Groundwater Remedy Phase 1 Construction, PG&E Topock Compressor Station, Needles, California

Work Variance Request #3 – Proposed changes within the Construction Headquarters (CHQ) fence line

Revised Drawings for Work Variance Request #3

Drawings from Approved Final Design (November 2015)

TOPOCK GROUNDWATER REMEDIATION PROJECT
CHQ REMEDY PRODUCED WATER TANK PAD PLAN AND SECTION
GAS TRANSMISSION & DISTRIBUTION
PACIFIC GAS AND ELECTRIC COMPANY
SAN FRANCISCO, CALIFORNIA

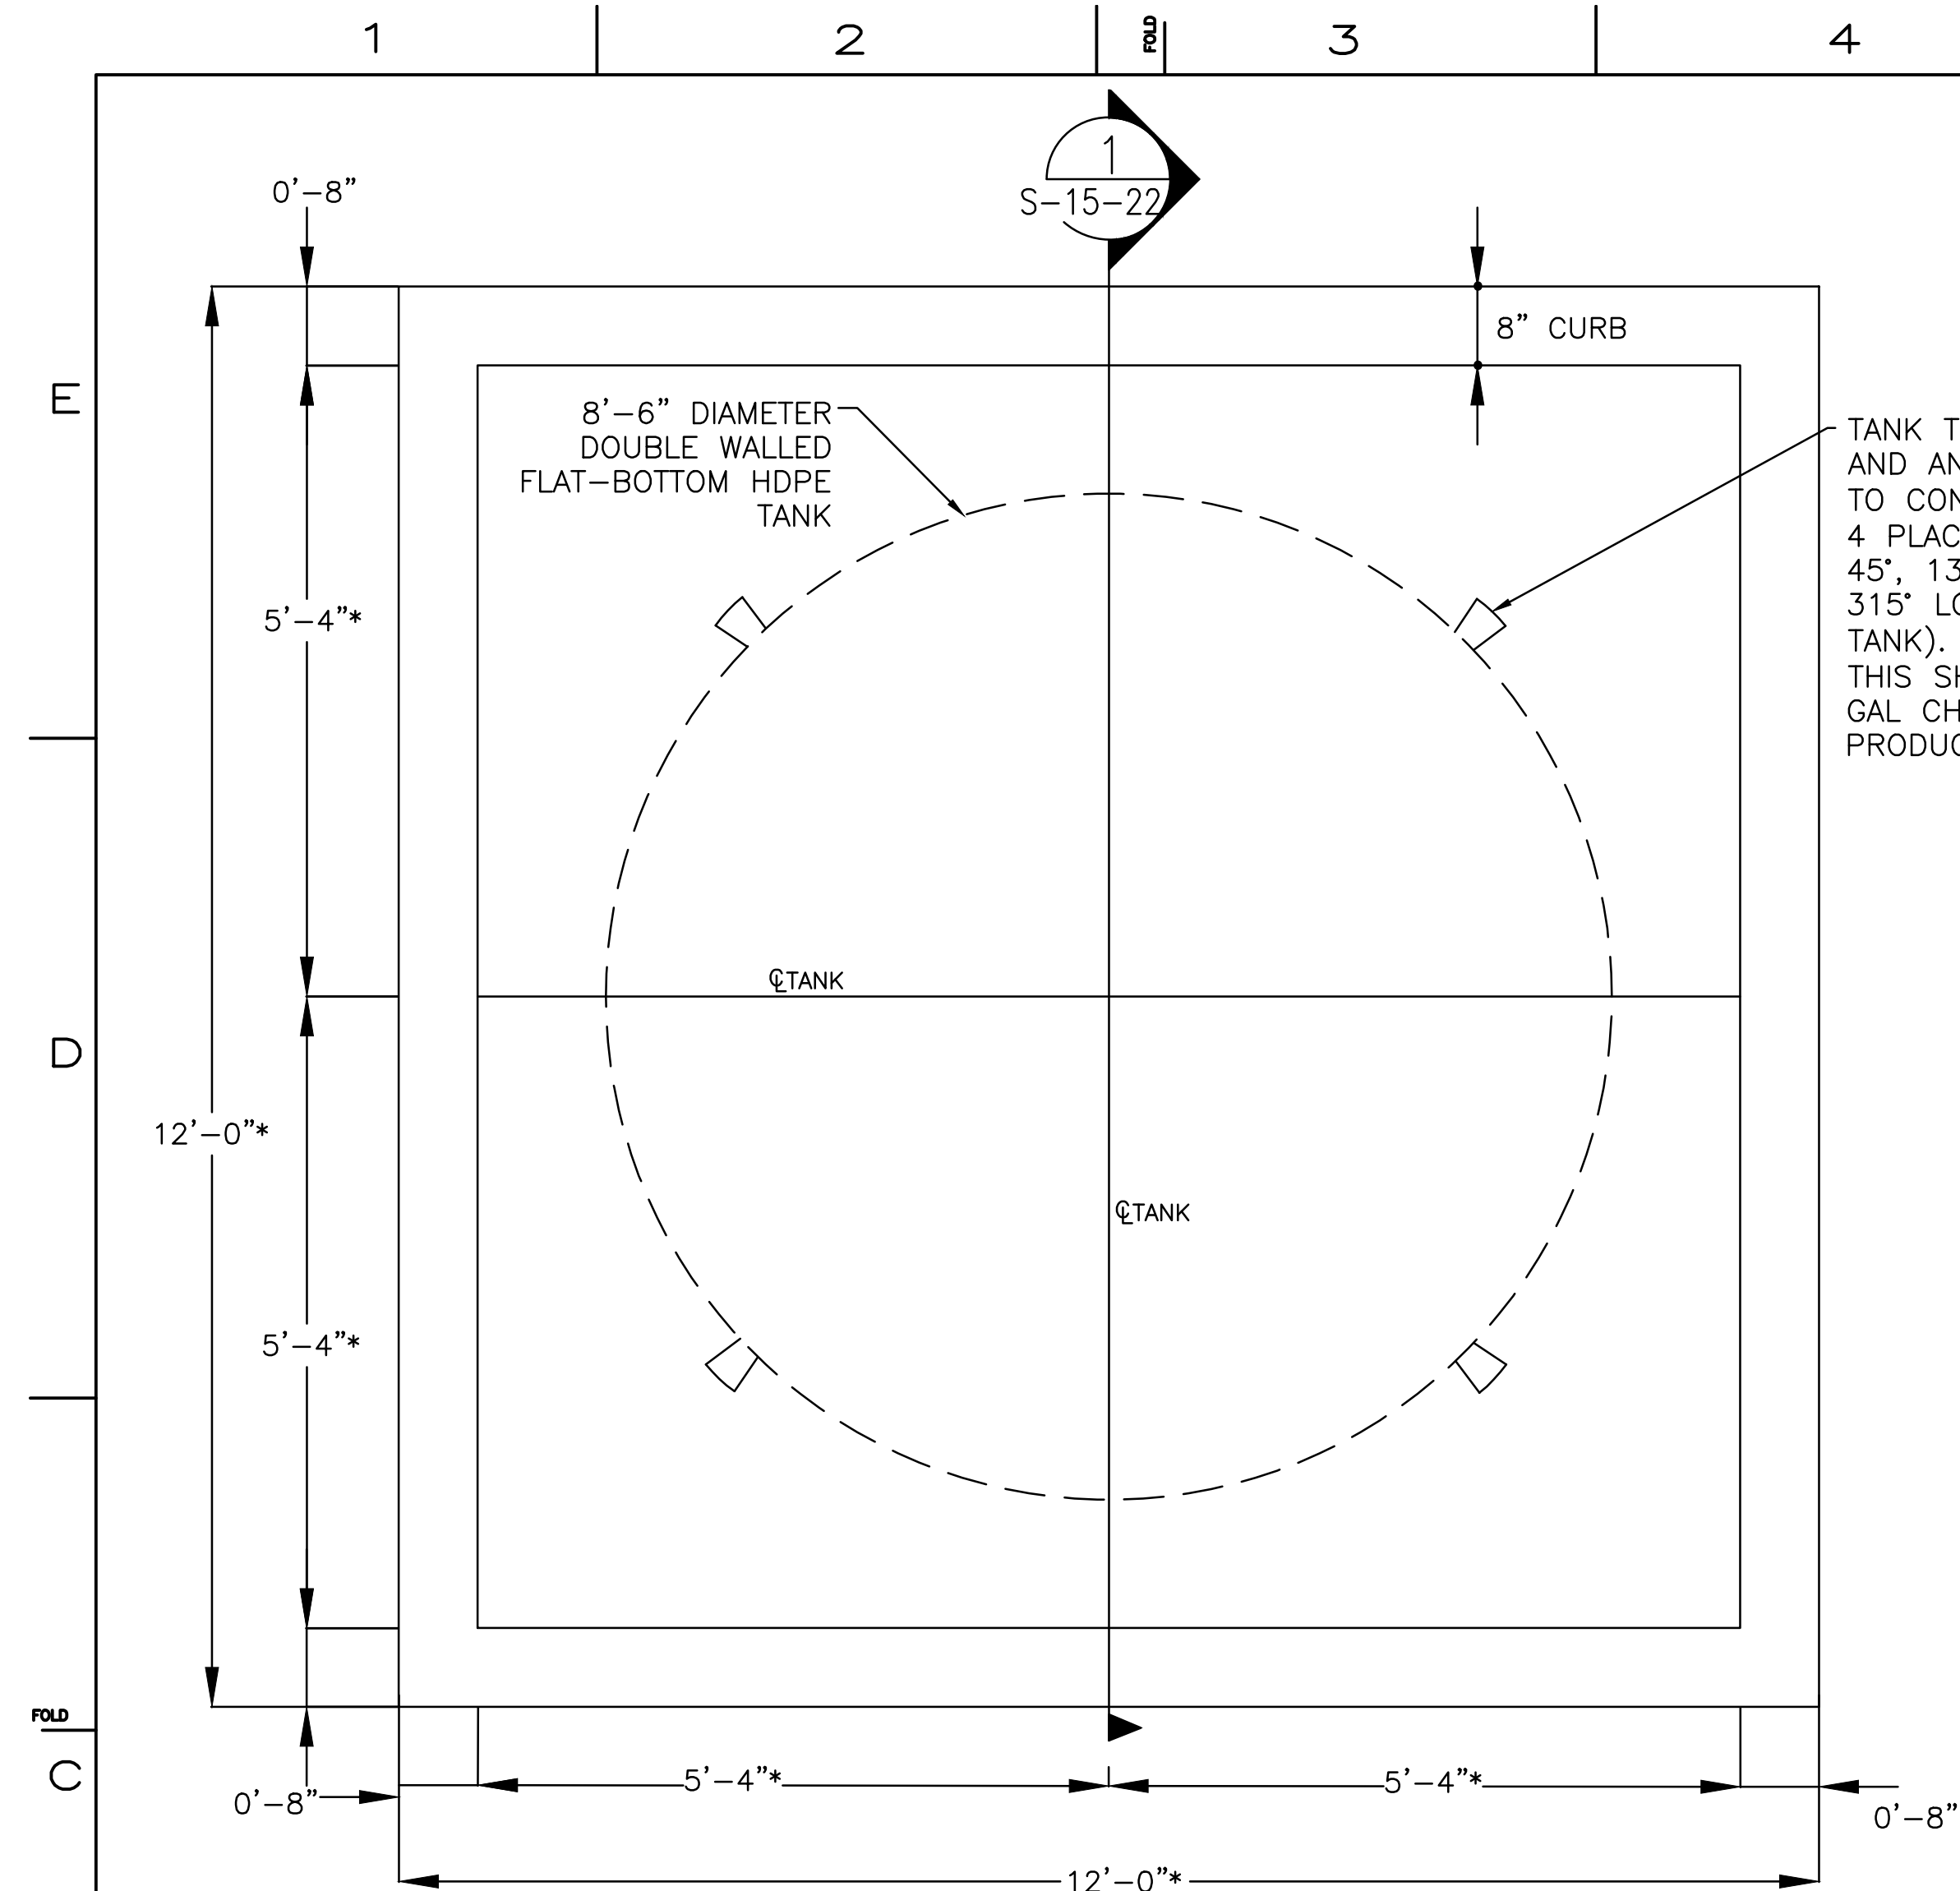
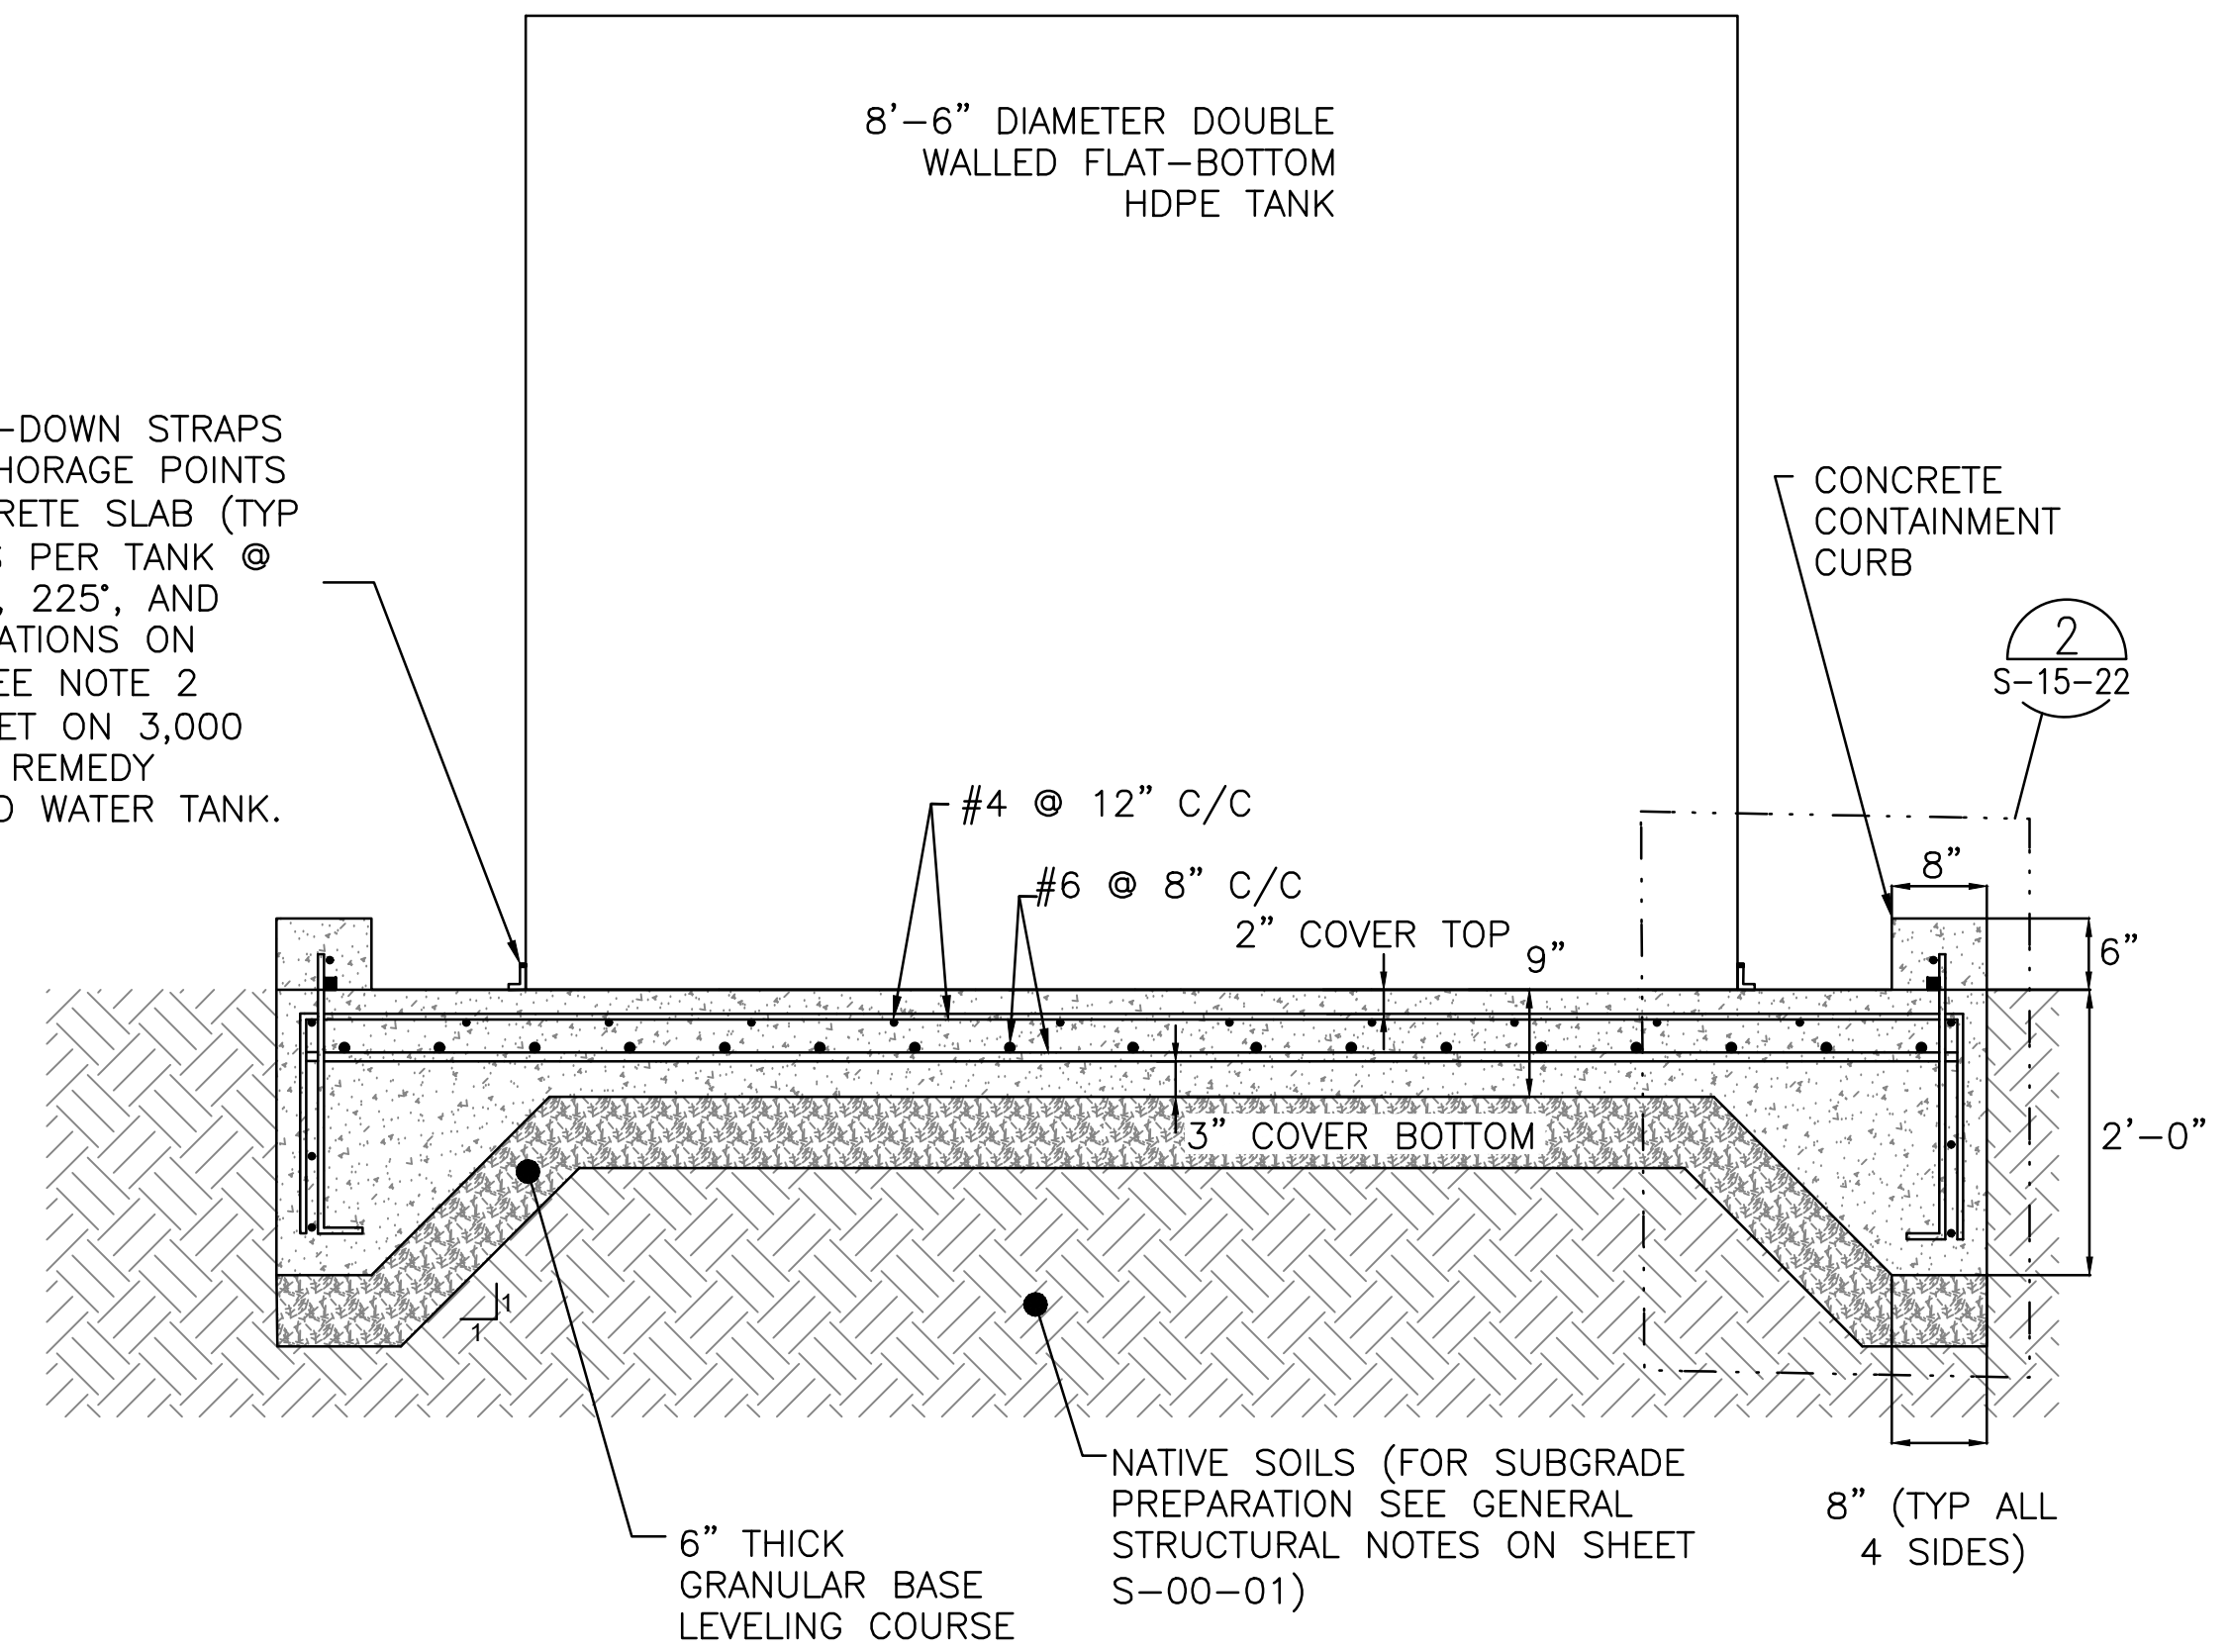
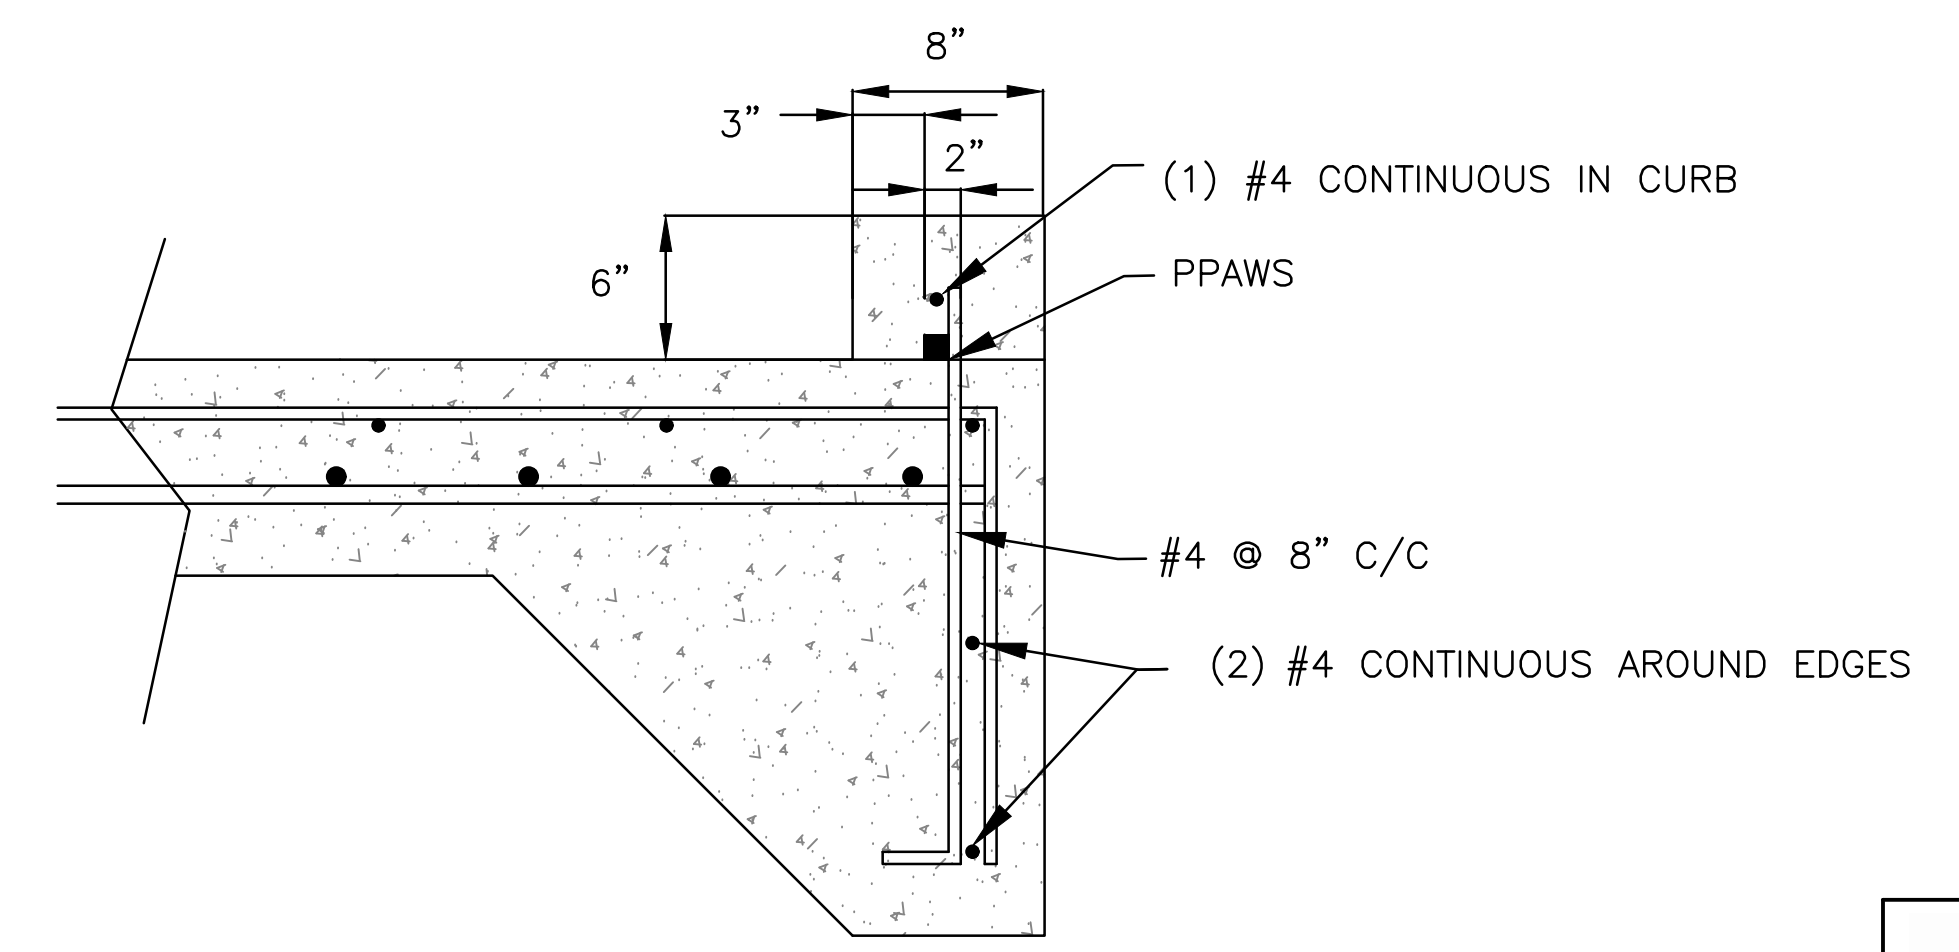
- b) **Bring the remedy-produced wastewater tank from belowground to aboveground, increase the tank volume from 1,000 to 2,500 gallons, and place the aboveground, double-walled tank adjacent to the decontamination pad.** The change from belowground to aboveground reduces the amount of soil disturbance by at least 50 cubic yards. The change to a bigger tank will reduce the amount of truck trips needed to haul wastewater. The placement of the tank adjacent to the decontamination pad allows for the pad to function as a secondary containment for the haul truck during off-loading of the wastewater.

- TANK TIE-DOWN STRAPS AND ANCHORAGE TO CONCRETE SLAB (FOR SEISMIC AND WIND LOADS SHOWN ON SHEET S-15-22) ARE TO BE DESIGNED AND PROVIDED BY TANK MANUFACTURER. HOWEVER, A MINIMUM OF 4 TIE-DOWN STRAPS (EQUALLY SPACED AROUND PERIMETER) TO BE PROVIDED. EACH TIE-DOWN STRAP TO HAVE A MINIMUM OF (1)-1/2" DIAMETER GALVANIZED ADHESIVE ANCHOR @ 4" MINIMUM EMBEDMENT (TANK MANUFACTURER TO DESIGN TIE-DOWN TO ADHESIVE ANCHOR CONNECTION). TANK MUST ALSO HAVE A MINIMUM OF (4)-L6x3 1/2 x 3/8 x 8" LONG CLIP ANGLES LLV WITH (1)-1/2" DIAMETER GALVANIZED ADHESIVE ANCHOR WITH 4" EMBEDMENT IN EACH CLIP ANGLE. SPACE 4 CLIP ANGLES EQUALLY AROUND TANK PERIMETER.

- STRUCTURAL DESIGN OF FOUNDATION SLAB ASSUMES A 3,000 GALLON CHQ REMEDY PRODUCED WATER TANK OF THE FOLLOWING GEOMETRY:
 - APPROX 8'-6" DIA FLAT-BOTTOM TANK WITH FULL LEVEL AT APPROX 9'-7" ABOVE TOP OF SLAB AND TOP OF ROOF AT APPROX 12'-0" ABOVE TOP OF SLAB.

- TANK CAPACITY = 3,000 GALLONS WITH LIQUID SPECIFIC GRAVITY SIMILAR TO WATER.
 - HDPE TANK CONSTRUCTION WITH EMPTY WEIGHT = 1,850#.
